**World Forum for Harmonization of Vehicle Regulations****Working Party on General Safety Provisions****109<sup>th</sup> session**

**Report of the Working Party on General Safety Provisions  
on its 109<sup>th</sup> session (29 September – 2 October 2015)****Addendum 1****Contents**

### **Draft 07 series of amendments to Regulation No. 107 (para. 6) (superseding ECE/TRANS/WP.29/GRSG/2015/32)**

Figure 10  
Distances for test fire #2

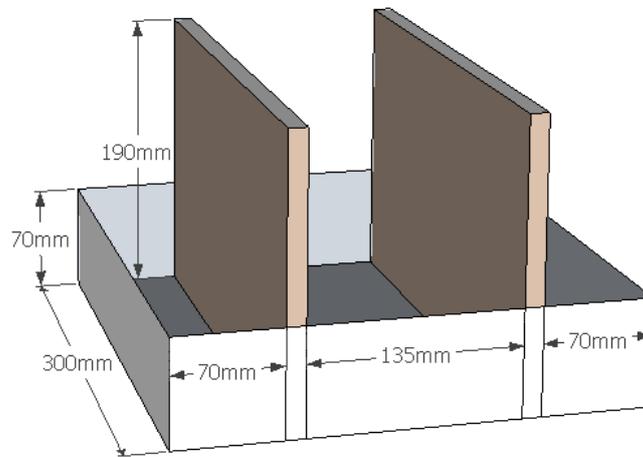
- 1.10.2. The square pool fire trays with fibreboards and the rectangular pool fire trays shall be positioned in its orientation according to the test scenarios in Appendices 2 to 4. Figure 10 shows the dimensions for test fire #2. The test fire shall be positioned perpendicular to the long edge of the test apparatus.
